Device TC23x
Marking/Step ES-AC, AC
Package see Data Sheet

No. 063/18

This Errata Sheet describes the deviations from the current user documentation.

Figure 1 Message buffer transfer from Message RAM to OBF

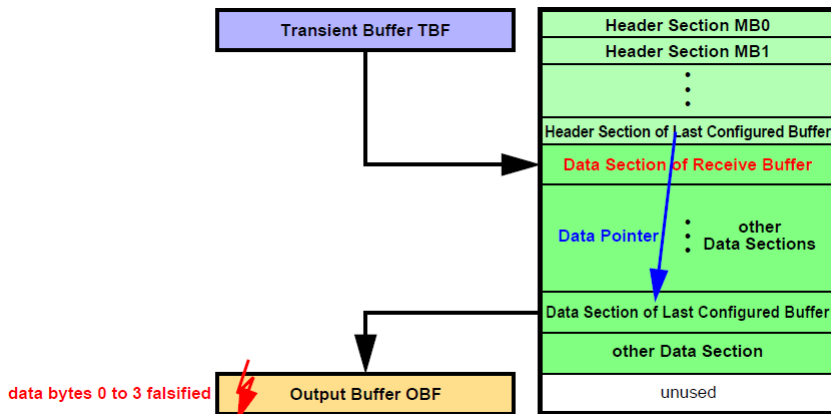
When the message buffer has its payload configured to maximum length (**PLC** = 127), the OBF word on address 00h (payload data bytes 0 to 3) is overwritten with unexpected data at the end of the transfer.

a) When a message is transferred from the Last Configured Buffer in the Message RAM to the OBF and **PLC** = 127 it may happen, that at the end of the transfer the OBF word on address 00h (payload data bytes 0 to 3) is overwritten with unexpected data (see [Figure 1](#)).

Figure 2 Message buffer transfer from IBF to Message RAM

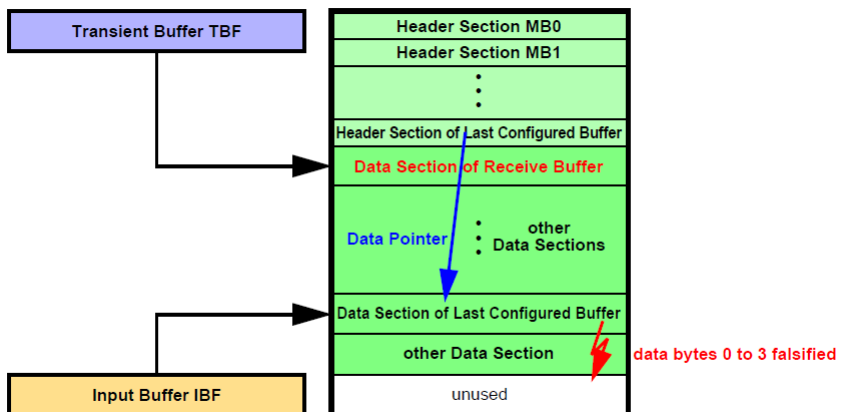
After the Data Section of the selected message buffer in the Message RAM has been written, one additional write access overwrites the following word in the Message RAM which might be the first word of the next Data Section.

b) When a message is transferred from IBF to the Last Configured Buffer in the Message RAM, it may happen, that at the end of the transfer of the Data Section one additional write access overwrites the following word, which may be the first word of another message's Data Section in the Message RAM (see [Figure 2](#)).

Figure 3 Message RAM Configurations

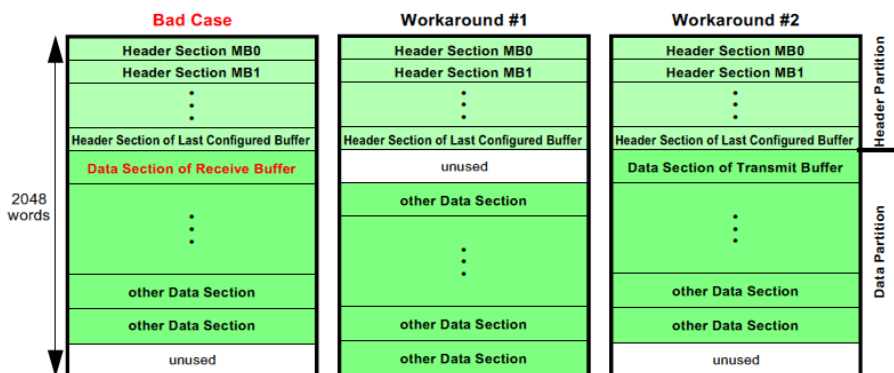
The erratum is limited to the case when (see [Figure 3](#) "Bad Case"):

- 2) Ensure that the Data Section directly following the Header Partition is assigned to a transmit buffer.

Figure 5 Transmitter - losing CAN FD node

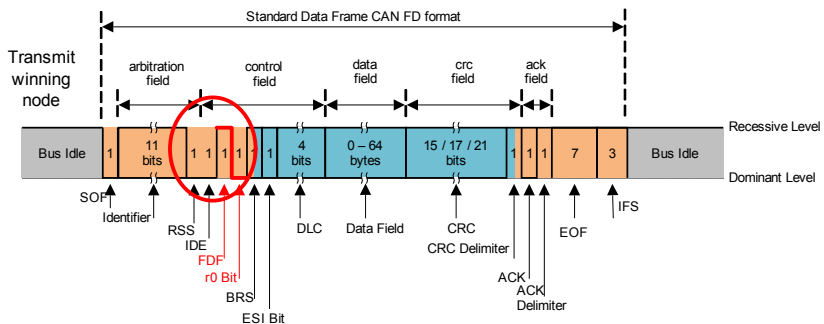
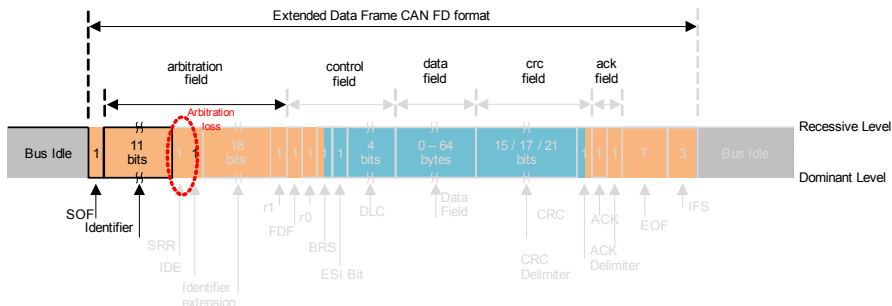
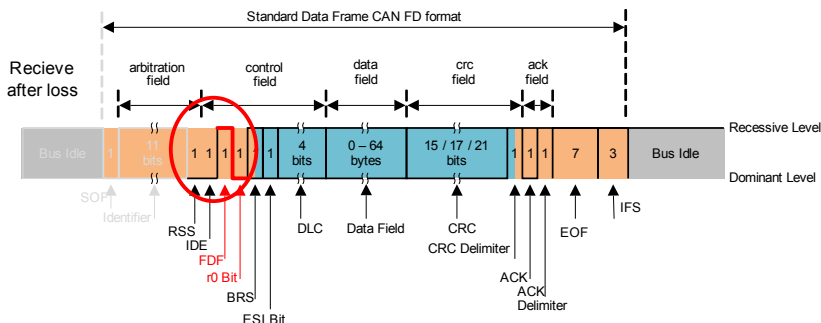
If a transmitter is losing arbitration late (e.g. in an extended frame - see [Figure 4](#) the node which wins arbitration and [Figure 5](#) the transmitting node loosing arbitration), then the FDF bit to res bit is the last chance to synchronize to the winning node (here as a receiver [Figure 6](#) the same node as in [Figure 5](#)). A timing offset will occur between the now receiving node and the actual transmitter.

The device is producing more error frames within a network than a device with a hardsync at the FDF bit.

Figure 12 Ripple Voltage vs. Frequency Characteristic

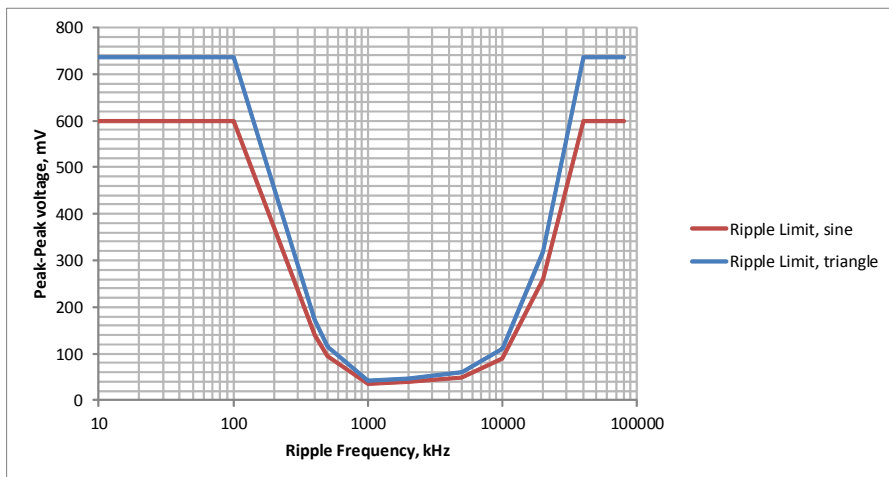
The internal back-up clock is sensitive to specific power supply voltage disturbance/ripple caused by a voltage ripple intrinsic to DC-DC converters. Specific conditions such as insufficient filtering of the ripple may lead to improper behavior of the start-up scheme of the back-up clock, and thus stuck-at state during the start-up of the microcontroller until this condition is removed.

The acceptable voltage vs. frequency characteristic is portrayed below on the chart:

The diagram reflects acceptable ripple level during the cold start of the microcontroller at the VDDP3 supply of the PMS subsystem. For devices in QFP-144, QFP-100 and QFP-80 packages the ripple is reflected for pin 69, pin 47, and pin 37, respectively.

Figure 13 Short Serial Message, Serial Data Encoding over 16 messages

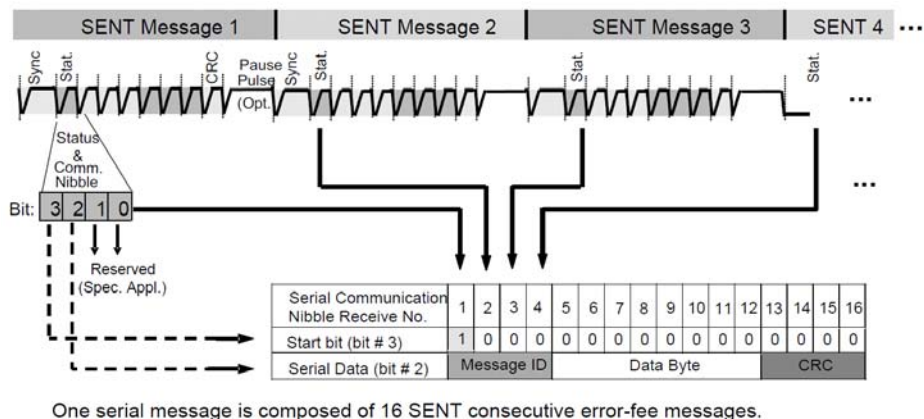
Correction

Figure 13 shows a corrected version of this figure.
